STANDARD DEPARTURE CHART-INSTRUMENT

RJFN / NYUTABARU

NIPPO SEVEN DEPARTURE

SAITO ONE DEPARTURE

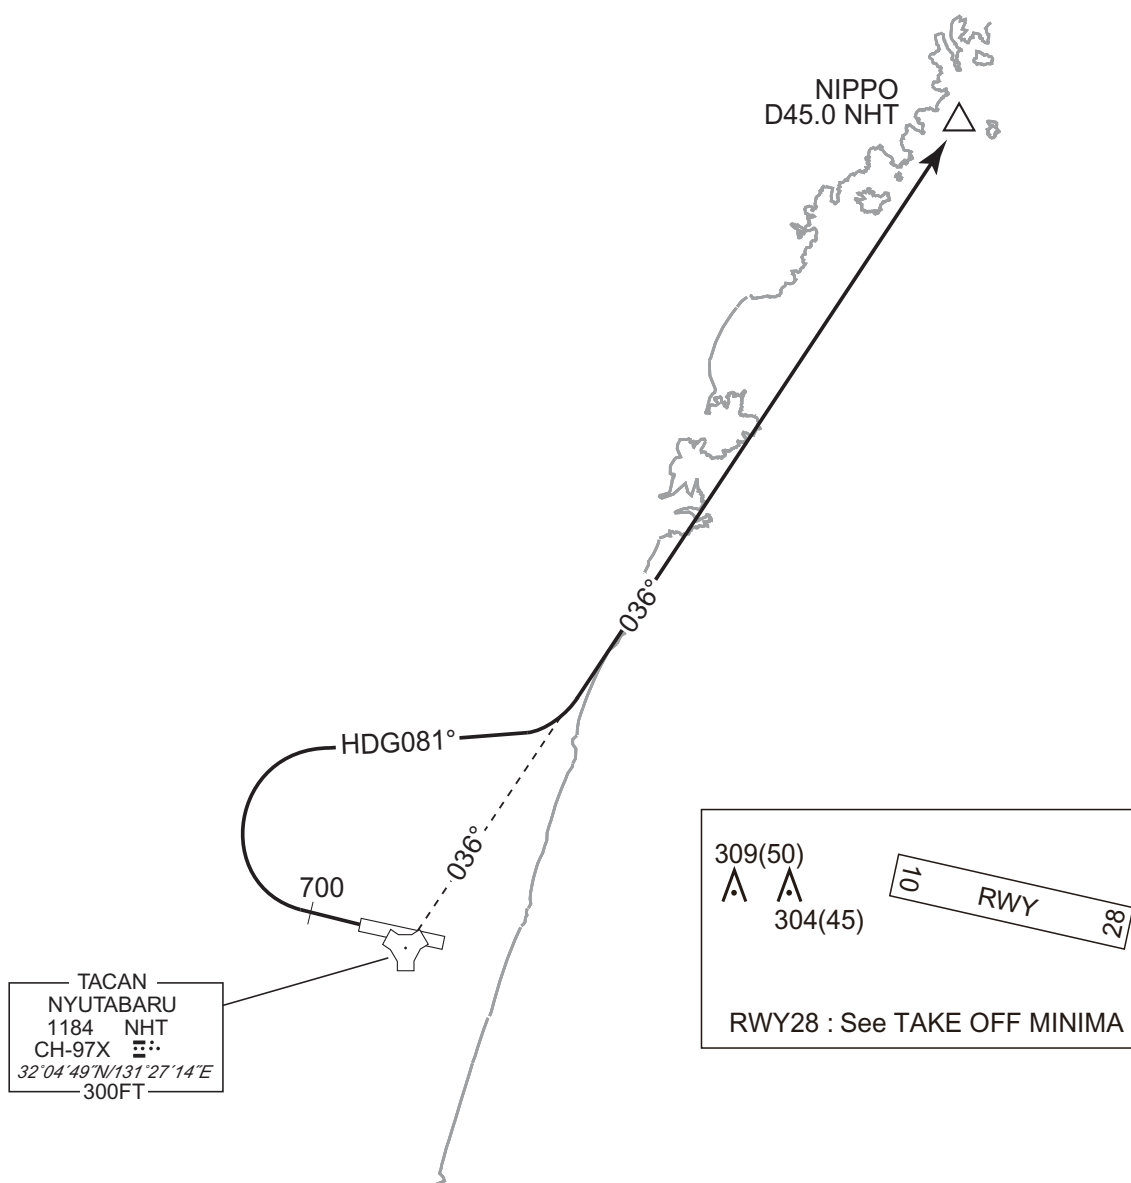
CHANGE : New PROC.

RWY28 : Climb RWY HDG to 700FT, turn right HDG 081° to intercept and proceed via NHT R036 to NIPPO.

Note RWY28 : 5.0% climb gradient required up to 4000FT.

OBST ALT 1871FT located at 6.3NM 334° FM end of RWY28.

TACAN Z RWY28

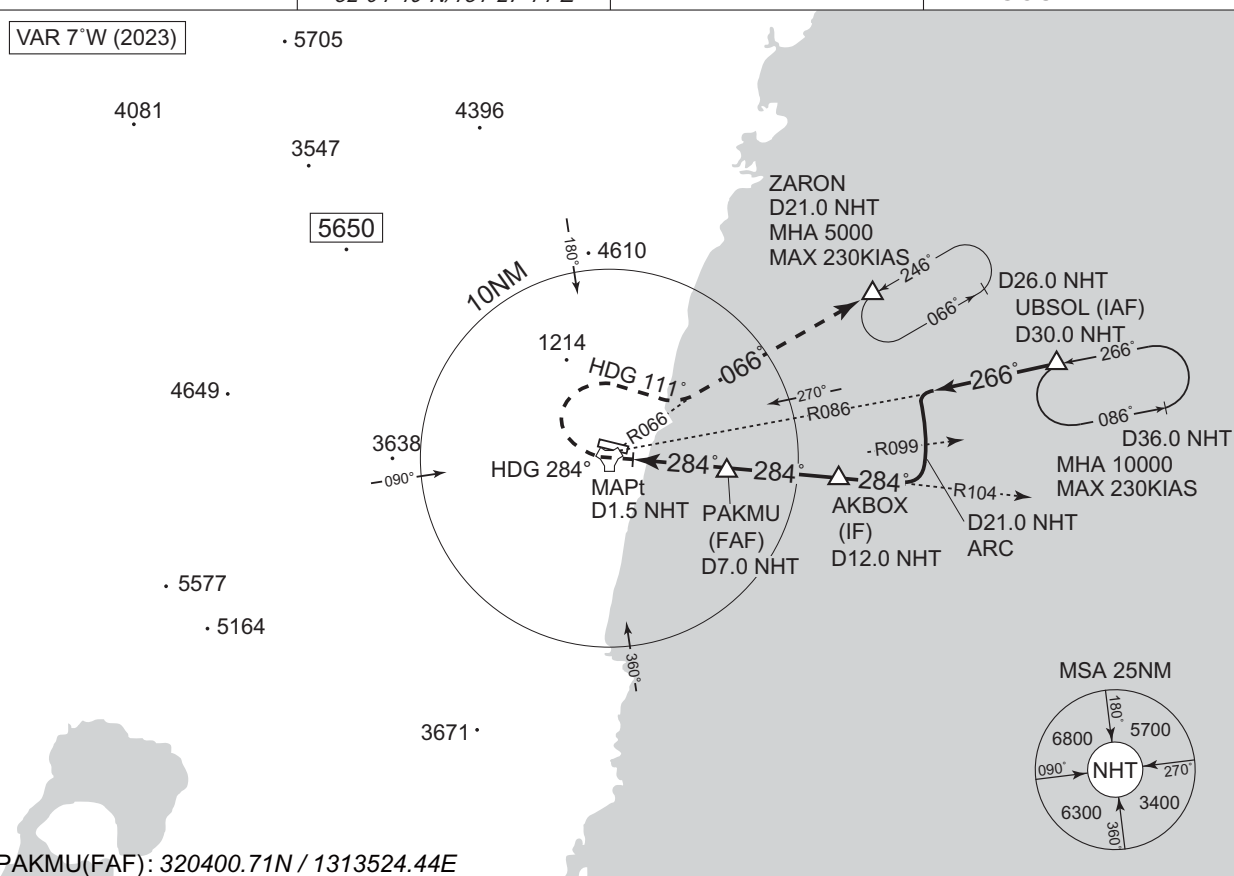
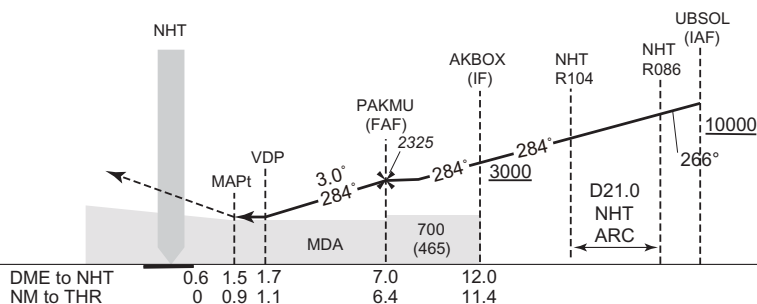
CHANGE : PROC course. Missed APCH course. MINIMA. UBSOL, PAKMU, AKBOX established. NM to THR. ALT(3.0°APCH Path), DME to NHT added.
Missed APCH climb gradient MNM added. VAR.

Climb to 700FT on HDG 284°,
turn right HDG 111° to intercept
and proceed via NHT R066 to
ZARON and hold at 5000FT.
Contact KAGOSHIMA APP.

Missed APCH climb gradient MNM 3.0%

MINIMA with Missed APCH climb gradient of 2.5% are not established.

ILS Y or LOC Y RWY28

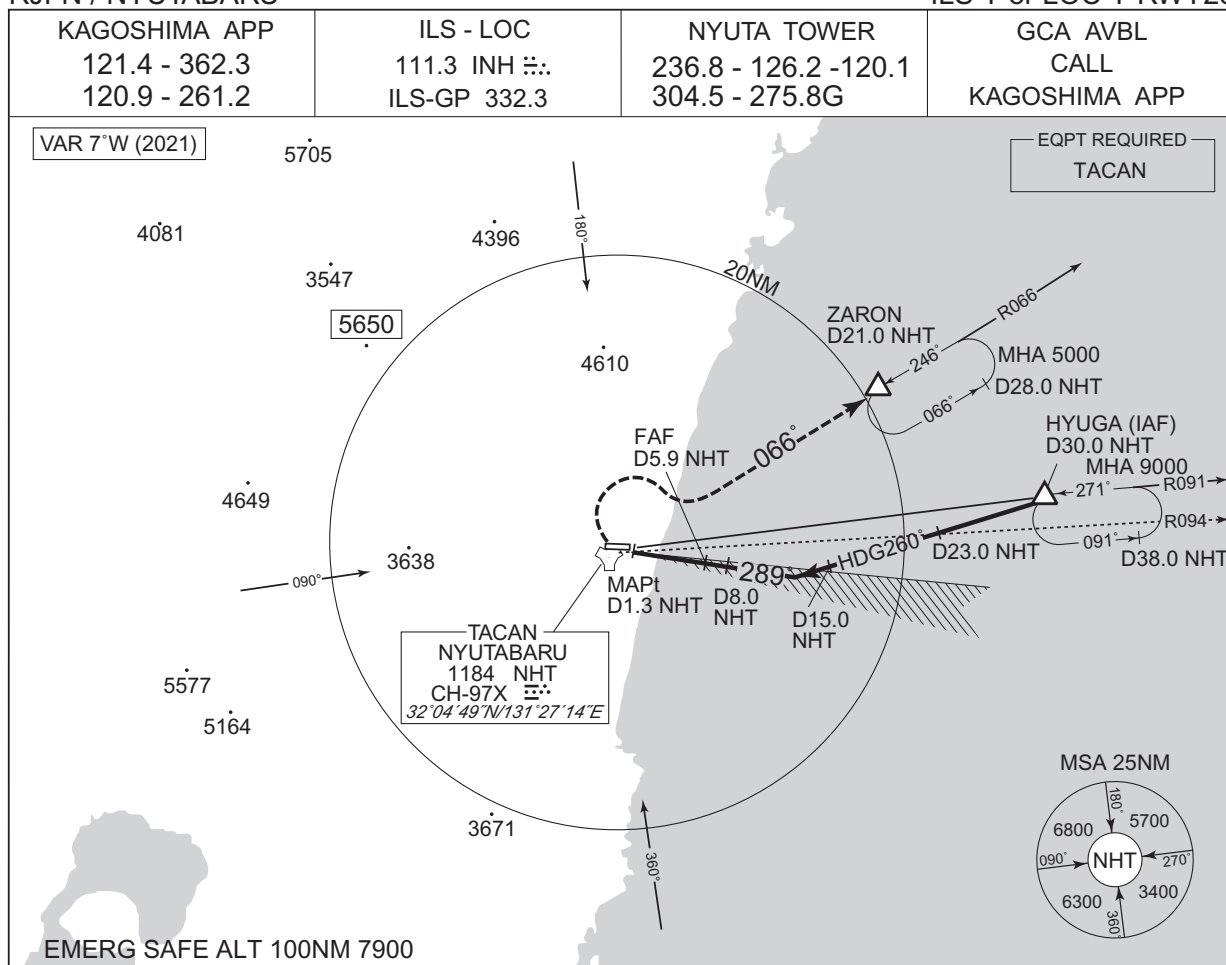
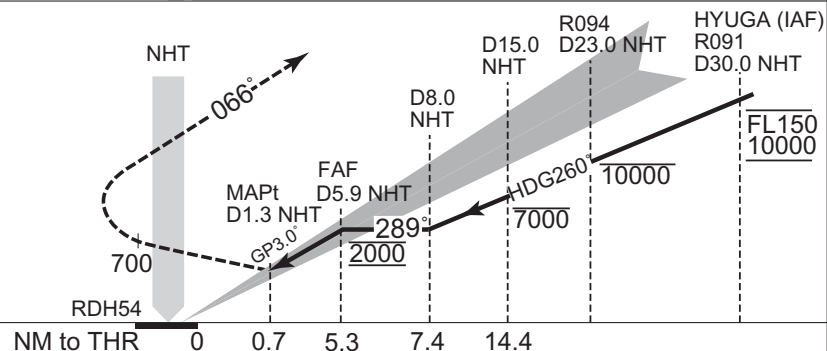
CHANGE : VAR. PROC renamed. EQPT REQUIRED added. PROC course. MISSED APPROACH course. MSA.
NM to THR added. MDA(H) for CIRCLING.

Climb to 700FT, turn right
climb via NHT TACAN R066 to
ZARON to 5000FT and hold.
Contact KAGOSHIMA APP.
